ZONING DIVISION  
LEE COUNTY  
PLANNED DEVELOPMENT SUFFICIENCY REVIEW  
TRANSMITTAL SHEET

PROJECT NAME: BERMUDA LAKES RV RESORT RVPD

CASE #: DCI2014-00010

Re: The 06/24/14 Revised Sufficiency Response Submittals

Crystal Lakes RV Resort, Naples, FL

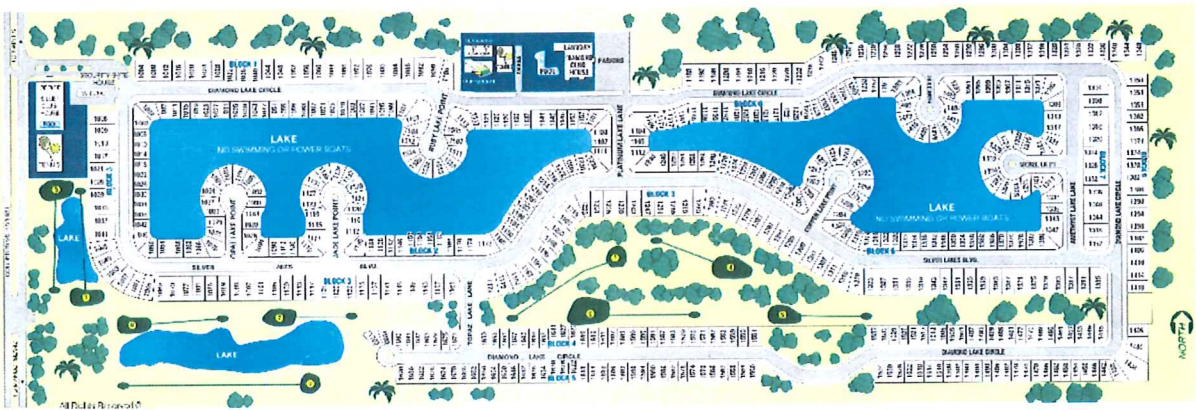
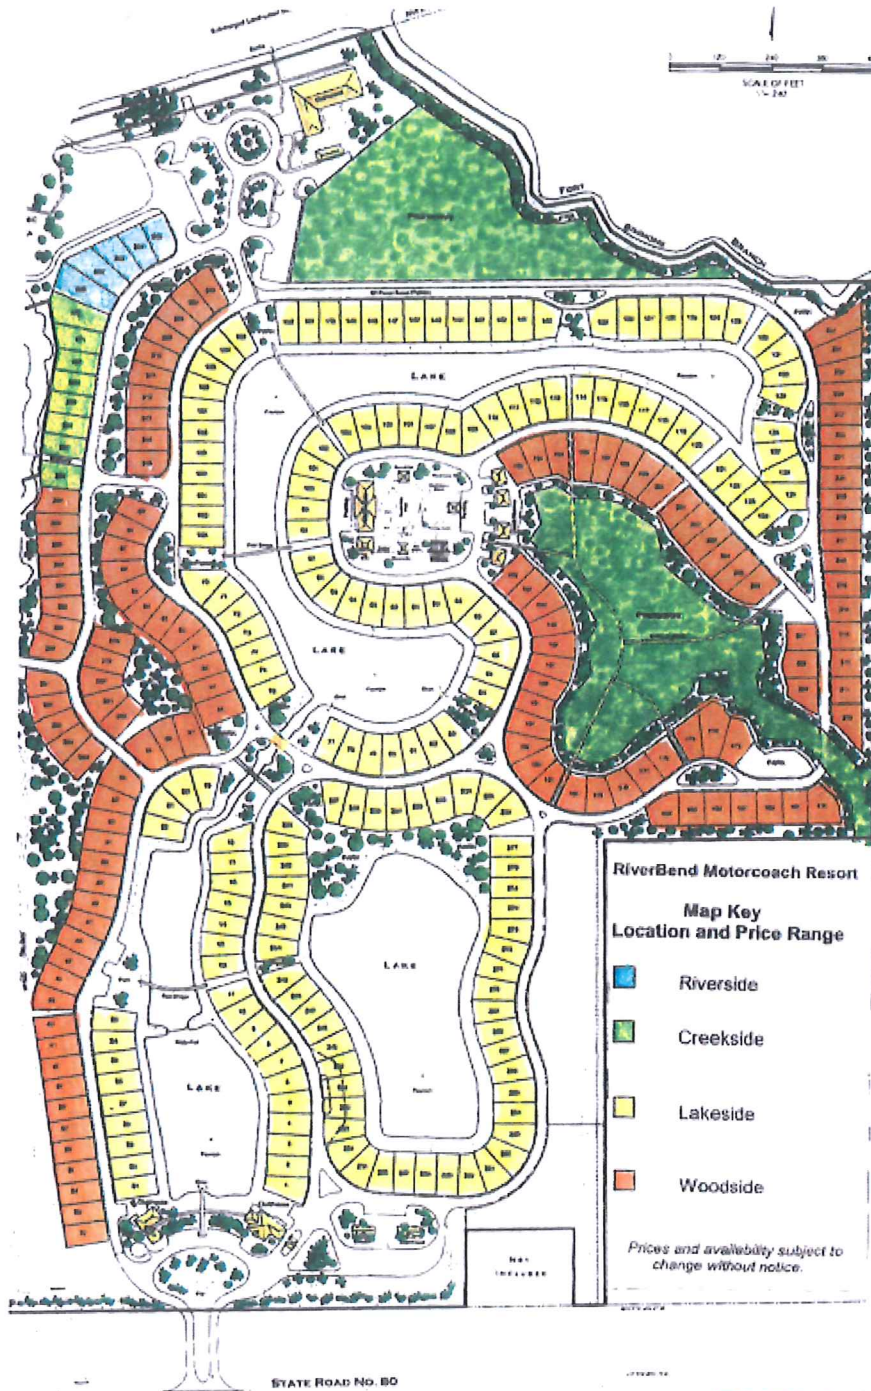
open space is significant. This is brought about by a number of factors, including the existing lake and the three onsite wetland systems. When taking into account the total lake area (10.2 acres), the Indoor and Outdoor Recreation Area (2.3 acres) and Dry Detention Drainage Area (1 acre), combined with 8.36 acres of native open space, 2.79 acres of site perimeter buffering and 1.16 acres of lake buffer, the project incorporates a true 25.81 acres of open space. This figure is equal to 53% of the total site area. Consequently relying on the project's low density and the site's 53% true open space, the need for an additional regulatory density cap vis-a-vis a minimal RV Site Size standard is not needed. As discussed within the June 18 Sufficiency Response, Items 11b1 & c, at this point in the process the Applicant does not know how wide and how large the RV sites will be (see below for revised 11b1 response). The Applicant will rely on his own considerable expertise in the final design and sizing of the project's RV sites. The project's other setback development standards are more than adequate in providing for a function and safe site development design. Finally, it is noted that the the RV industry really does not have a "typical" lot size or a "standard" area minimum. The 5,000 SF standard is an average that is not reflected in what is typically being built in the market. For example, the Crystal Lake RV Resort in Naples has a typical 40-ft. X 80-ft. lot (3,200 SF). The Silver Lakes RV Resort in Naples has both 45-ft.X90-ft. (4,050 SF) and a 35-ft.X70-ft. (2,450 SF) standards size sites. The East Lee County River Bend RV Resort has a 50-ft.X100-ft. (5,000 SF) standard site size. However, each site is sized to feature a 10-ft.X14-ft. or a 10-ft.X16-ft. on-site Coach Home. So the site size is inherently large. The project will benefit from not having a minimum site size by granting it greater flexibility to address site size market demands. This flexibility is needed due to the project's large open space areas and low density. Finally, there will be no deleterious effects upon adjoining and adjacent properties in that the standard is interior to the project. See the following pages for the three cited RV Resort Site Plans.

MASTER CONCEPT PLAN THE BURMUDA LAKES RV RESORT PLANNED DEVELOPMENT LEE COUNTY, FLORIDA						
DATE	PROJECT	DRAWING	DESIGN	DRAWN	CHECKED	SHEET
5/12/2014	2062NT	MCP		EMH		1

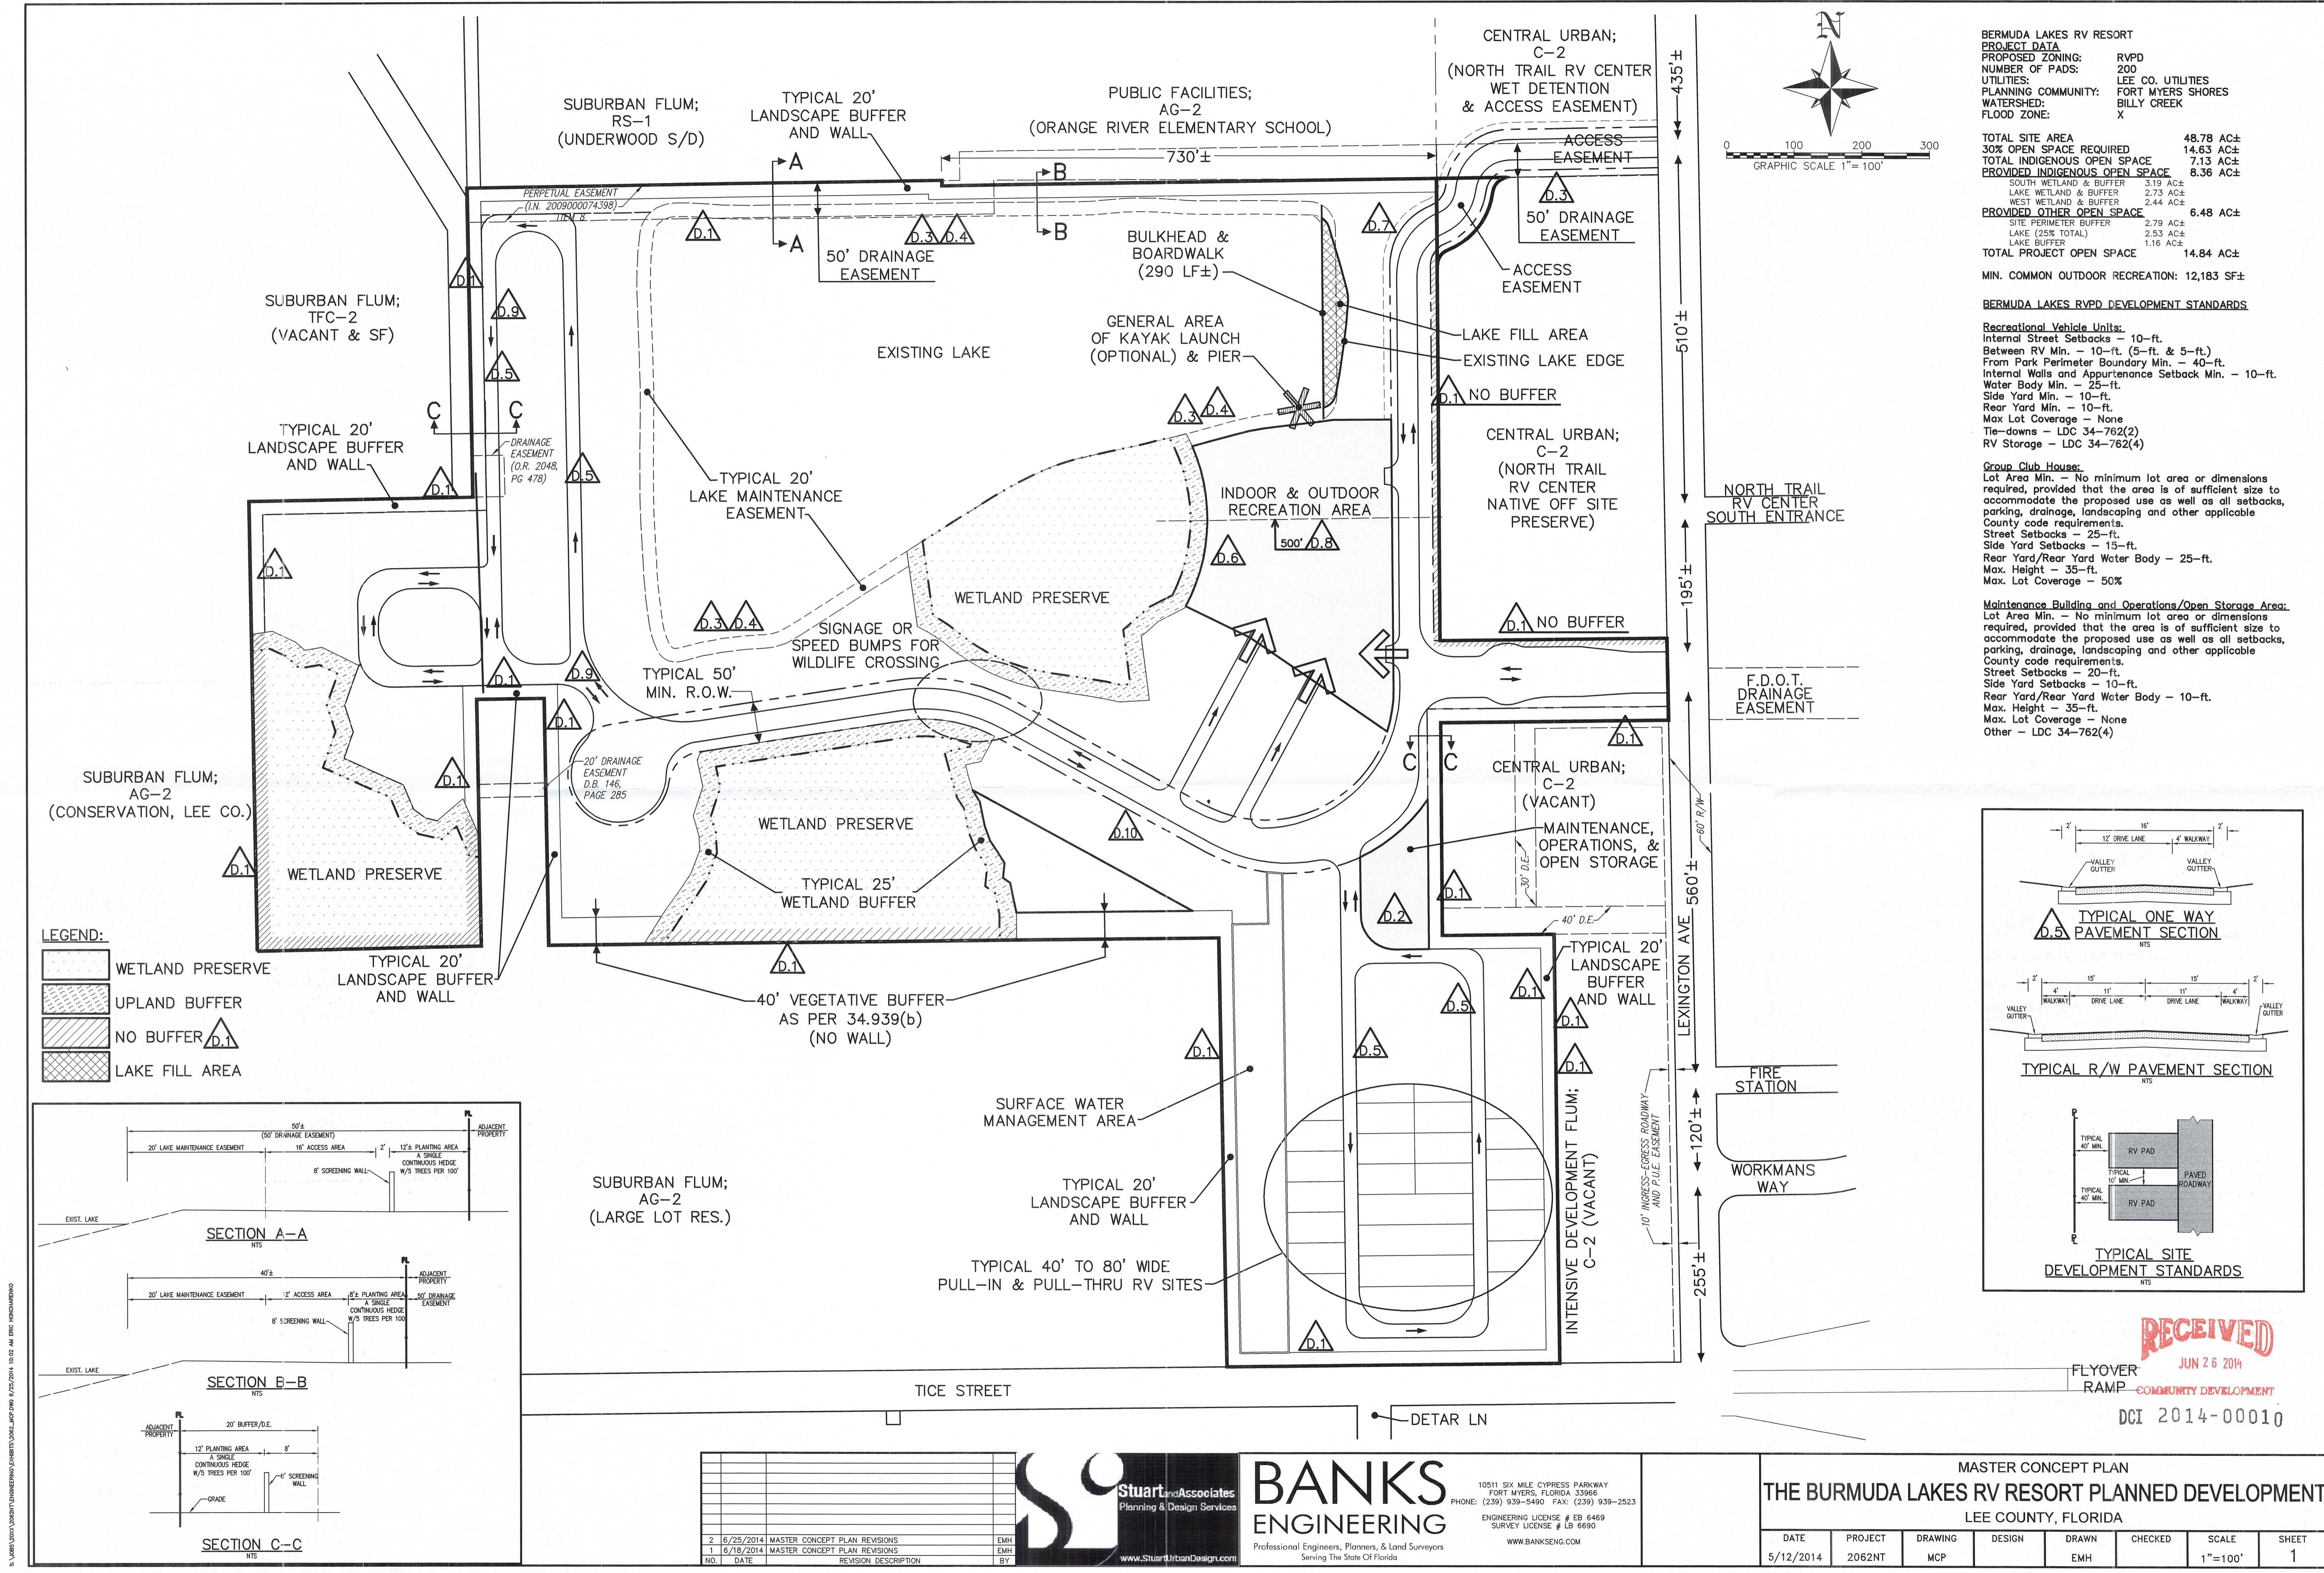
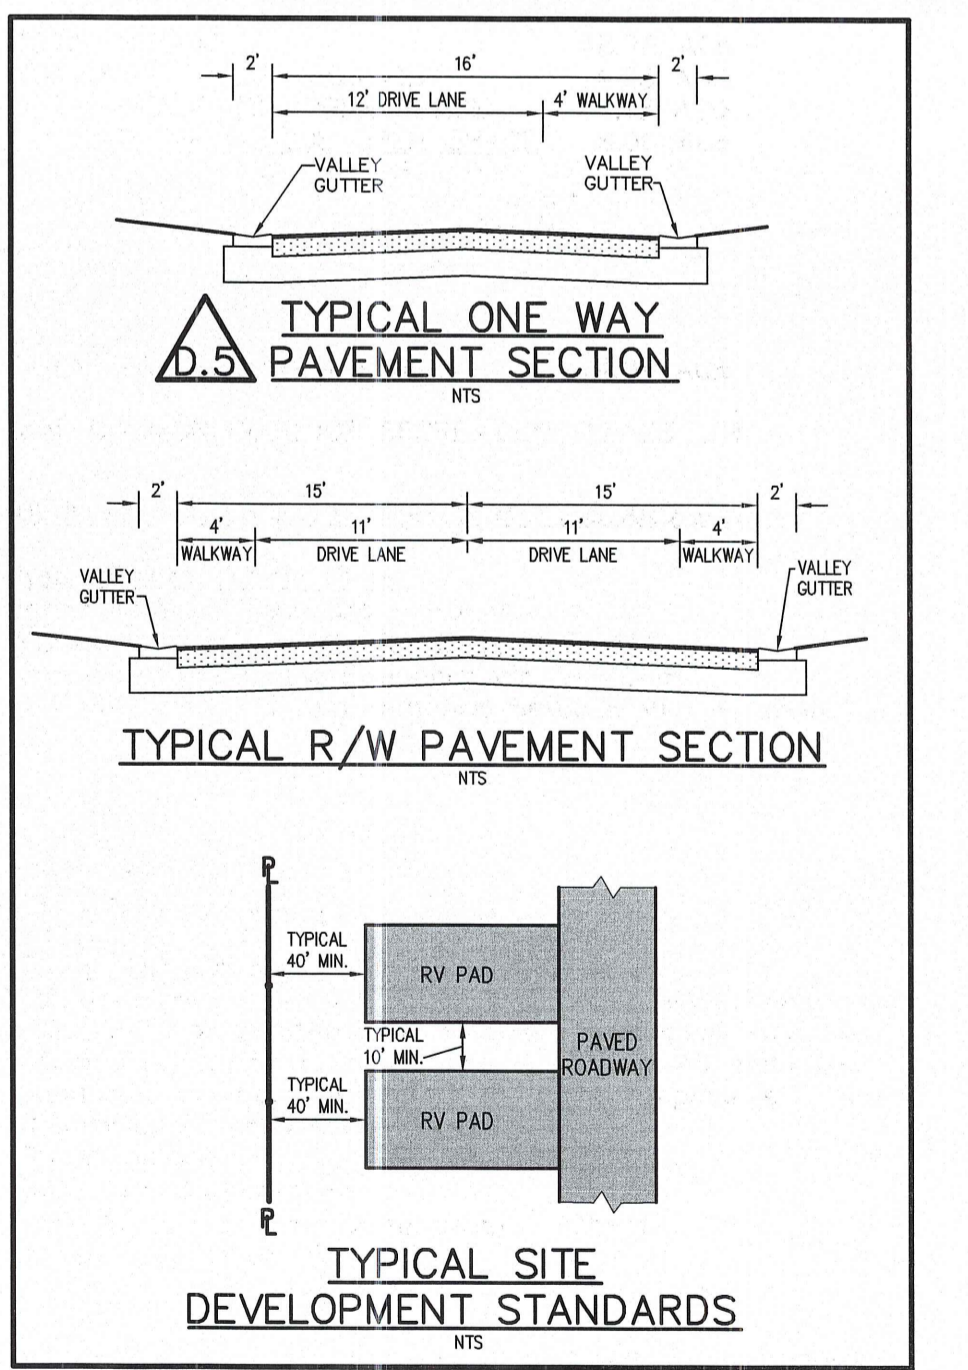
From a review of our recently resubmitted application and information, I noted a mistake that I made. To that end, for your review, please assess the revised Ex. 19 Deviation Schedule, Ex. 15 Development Standards, and revised Master Concept Plan. These three items include the revised minimum RV site size standard and minimum width. The request and explanation is identified as the new Deviation Ten.

Please refer to the revised RVPD Master Concept Plan. The MCP illustrates typical RV lots, both "Pull-in" and "Pull-thru". At this point in the process the Applicant does not know whether the internal RV pad width will be 40-ft. 50-ft., 70-ft. or 80-ft. wide. The proposed Development Standards specifies a minimum 35-ft. wide RV pad lot width. A complete copy of the project's requested Development Standards is attached to this correspondence and labeled Exhibit 15 Request Statement Development Standards.
